UNITED STATES PATENT AND TRADEMARK OFFICE

APPLICATION NO.	FILING DATE	FIRST NAMED INVENTOR	ATTORNEY DOCKET NO.	CONFIRMATION NO.
10/057,067	01/25/2002	Charles R. Sperry	D-30259-01	3363
7590 12/14/2004 Scaled Air Corporation (US) P.O. Box 464 Duncan, SC 29334			EXAMINER SIMONE, CATHERINE A	
			ART UNIT 1772	PAPER NUMBER

Office Action Summary

DETAILED ACTION

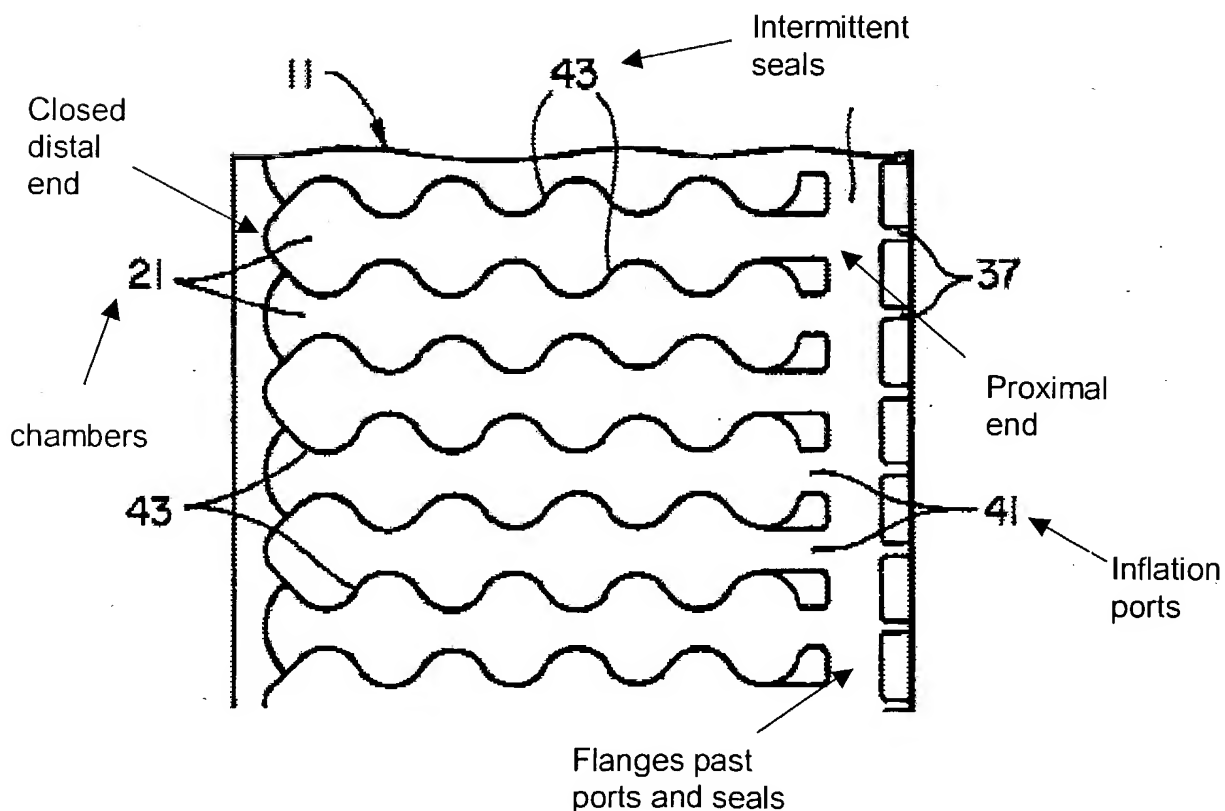
De Luca et al. discloses an inflatable web comprising two sheets (see col. 2, lines 47-51) having inner surfaces sealed to each other in a pattern defining a series of inflatable chambers (Fig. 2, #21) of predetermined length, each of the chambers (Fig. 2, #21) having at least one change in width over their length; an inflation port (Fig. 2, #41) located at a proximal end of each chamber, the inflation ports being formed by intermittent seals (Fig. 2, #43) between the sheets; and longitudinal flanges (see Figure shown below) formed by a portion of each of the sheets that extend beyond the inflation ports and intermittent seals. However, De Luca et al. fails to disclose the flanges having a pair of open, unsealed edges. Jostler et al. teaches that it is old and well-known in the analogous art to have longitudinal flanges having a pair of open, unsealed edges (Fig. 1a, #24a,b; also see col. 2, lines 39-45) for the purpose of filling the pockets (chambers) with some material in order to inflate them. Therefore, it would have been obvious to one of ordinary skill in the art at the time the applicant's invention was made to have modified the longitudinal flanges in De Luca et al. to have a pair of open, unsealed edges as suggested by Jostler et al. in order to inflate the chambers to produce a packaging material.

Regarding **claim 2**, note in De Luca et al. the chambers (Fig. 1, #23) comprise at least two inflatable sections of relatively large width connected by relatively narrow inflatable passageways (Fig. 1, #25). Regarding **claim 3**, note in De Luca et al. the inflation ports (Fig. 1, #41) are narrower in width than the inflatable sections of relatively large width (Fig. 1, #21). Regarding **claim 4**, note in De Luca et al. each of the sheets comprises a heat-sealable thermoplastic polymer on its inner surface (see col. 7, lines 3-5). Regarding **claim 5**, note in De Luca et al. the sections of relatively large width are circular (Fig. 1, #21) and capable of forming essentially spherical or hemispherical bubbles when inflated. Regarding **claim 6**, note in De

Luca et al. the pattern defining the inflatable chambers form uninflatable planar regions (Fig. 1, #43) between the inflatable chambers (Fig. 1, #21). Regarding **claim 7**, note in De Luca et al. the flanges inherently have a width of at least $\frac{1}{4}$ inch (see Figure shown below). Regarding **claim 8**, the flanges in De Luca et al. are substantially equal in width (see Figure shown below).

Regarding **claim 9**, note in De Luca et al. each of the inflatable chambers (Fig. 1, #21) has a closed distal end opposite from the proximal end of each chamber (see Figure shown below).
